# Sumter City-County Planning Commission

## MSP-15-27/HCPD-15-14, 1101 Broad St. (City)

**Request:** Request for Major Site Plan approval and Highway Corridor Protection District Design Review approval for a 4800 sq. ft. two-tenant building for a restaurant and undesignated commercial retail space.

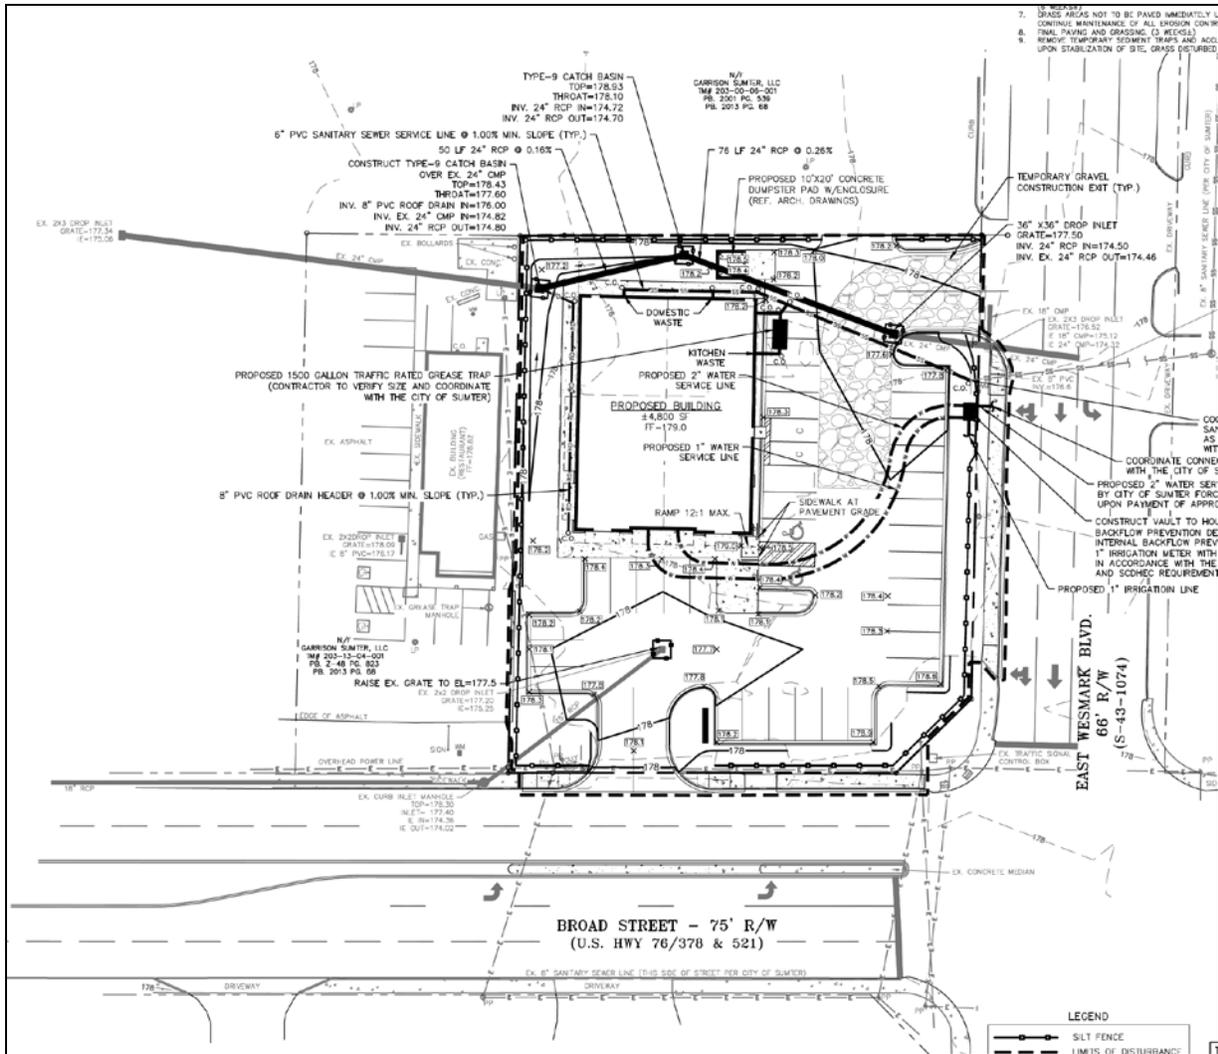
The minimum planting size for shrubbery in Type A Buffers is 3 gal./15 in. minimum height. The Applicant has proposed using Dwarf Yaupon Holly in the Type A Buffers on the interior side and rear of the parcel. This species of plant is not 15 in. tall at the 3 gal. size, therefore applicant is requesting permission to plant Dwarf Yaupon Holly that are 3 gal./10 in. minimum at time of planting. Due to the proposed location on the Yaupons, Staff finds this to be a reasonable request given the location of the proposed plantings.

Additionally, within the interior side Type A Buffer and along the Broad St. Street Landscape Buffer, the applicant has proposed replacing the required canopy trees with understory trees on a 2 for 1 exchange. This request is based on the placement of overhead power lines along Broad St. and the proximity of the adjacent commercial building on the interior side. Staff also finds this to be a reasonable request given the conditions on-site.

As proposed, this landscape plan meets the intent of the Ordinance.

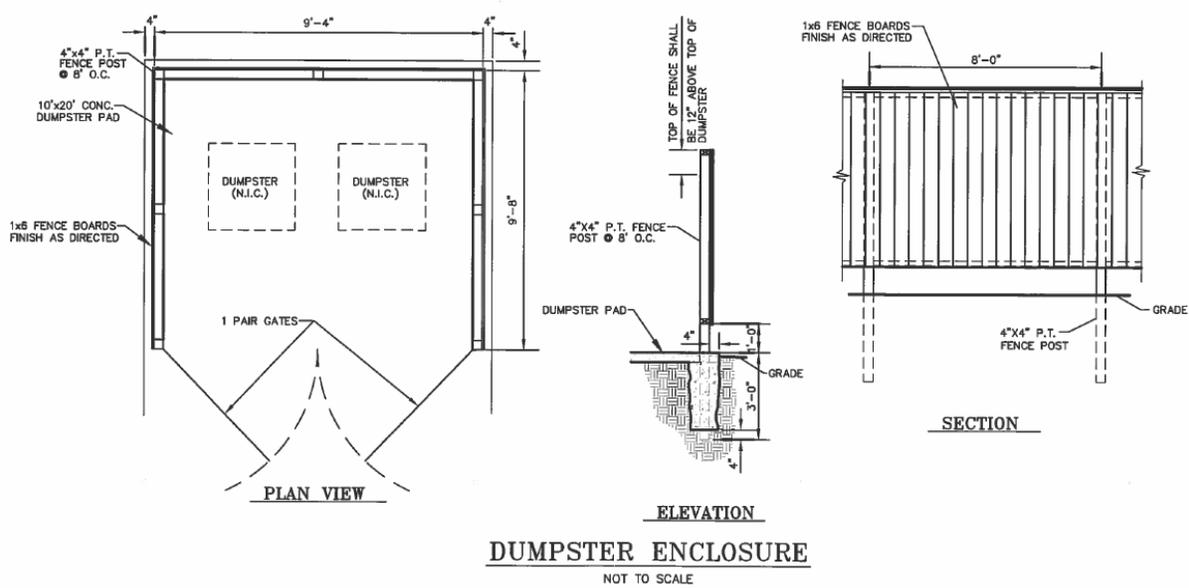
The exterior of the building will be a blend EIFS, stacked stone, and brick. Additionally, there will be black shed style awnings over the windows. The proposed elevations for the building are shown below. The primary building colors are earth tones. The proposed roof pitch is complementary to and compatible with the existing adjacent retail commercial structures in the area.
